State of New Jersey
Department of Environmental Protection and Energy
Division of Responsible Party Site Remediation
CN 028
Trenton, NJ 08625-0028

Re: Underground Storage Tank Closures
Case Numbers 93-03-03-1034 93-03-03-1500
 93-03-08-1205 93-03-08-1452
 93-03-08-1606 93-03-10-0851
 92-06-09-1446

The Department of Environmental Protection and Energy (NJDEPE) is in receipt of NAWCAD-Trenton's proposed ground water monitoring plan dated October 21, 1993. The monitoring plan was submitted to satisfy the requirements of seven underground storage tank removals with the above referenced Case Numbers in accordance with the NJDEPE's letters dated August 24, 27 and 31, 1993.

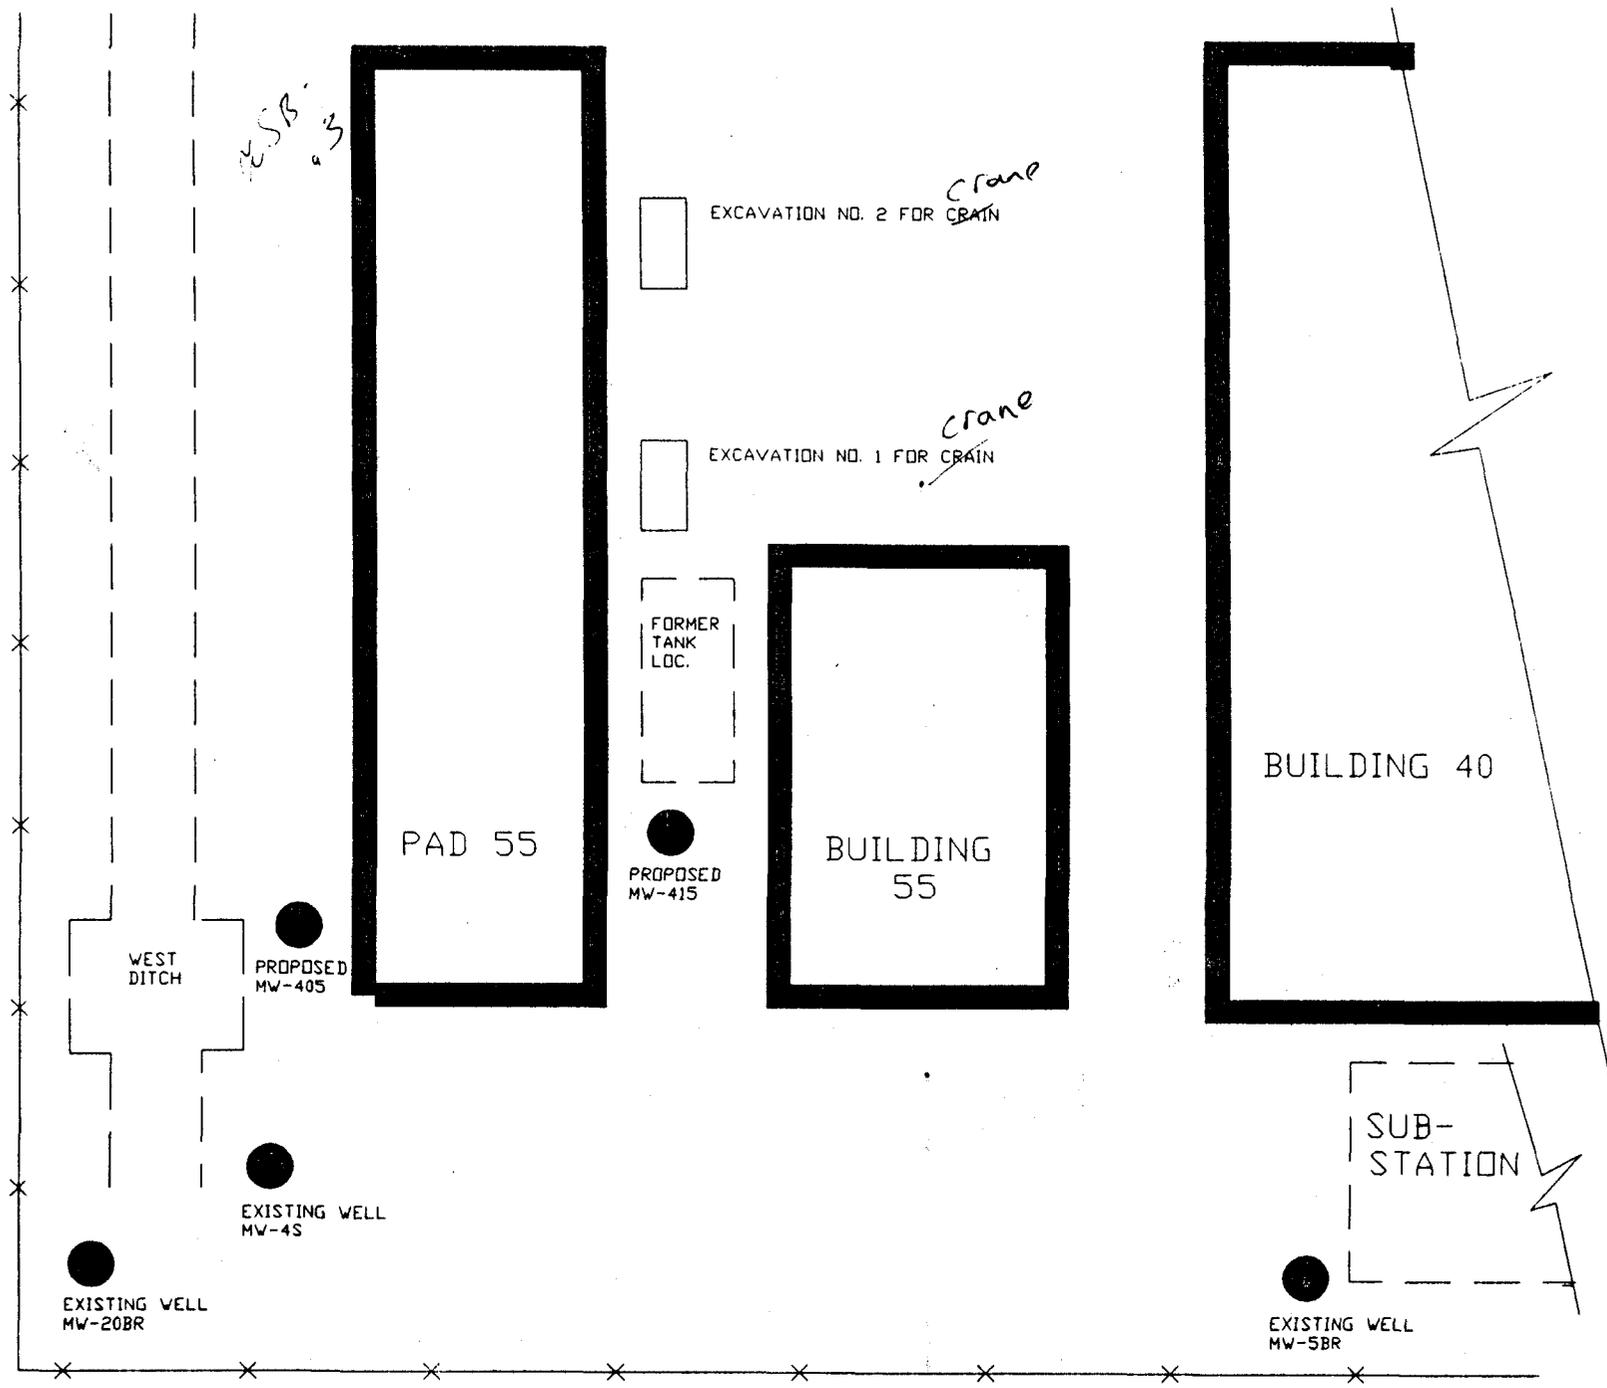
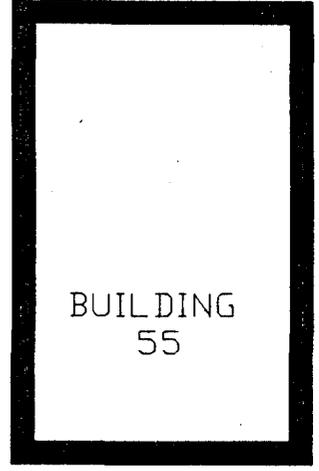
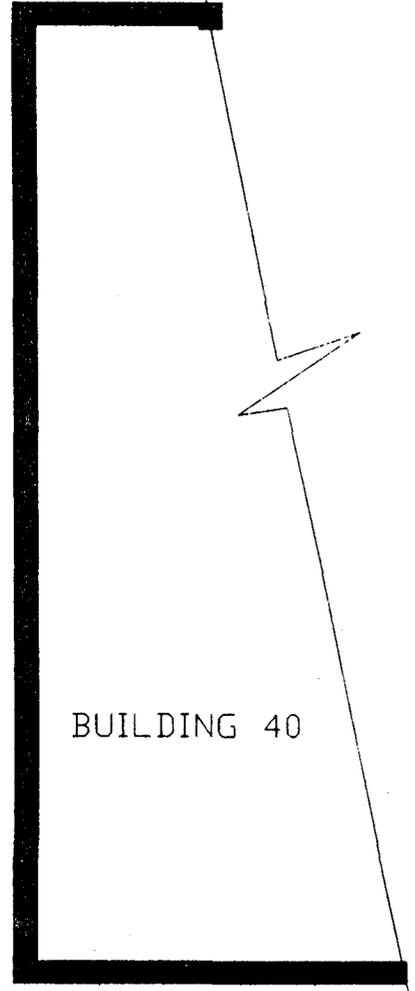
1. The monitoring plan specifies the screened intervals of each of the proposed monitoring wells. Be advised that all wells shall be screened across the water table. Therefore, the actual screened intervals may vary from those proposed based upon field conditions.
2. Base neutrals shall be analyzed by EPA Method 625, with a library search.
3. Volatile organics shall be analyzed using EPA Method 624, calibrated for xylenes, with a library search.
4. MW-36S (Tank E-4) shall be analyzed for volatile organics and methyl-tertiary-butyl-ether (MTBE) using EPA Method 624 calibrated for xylene and MTBE, with a library search.
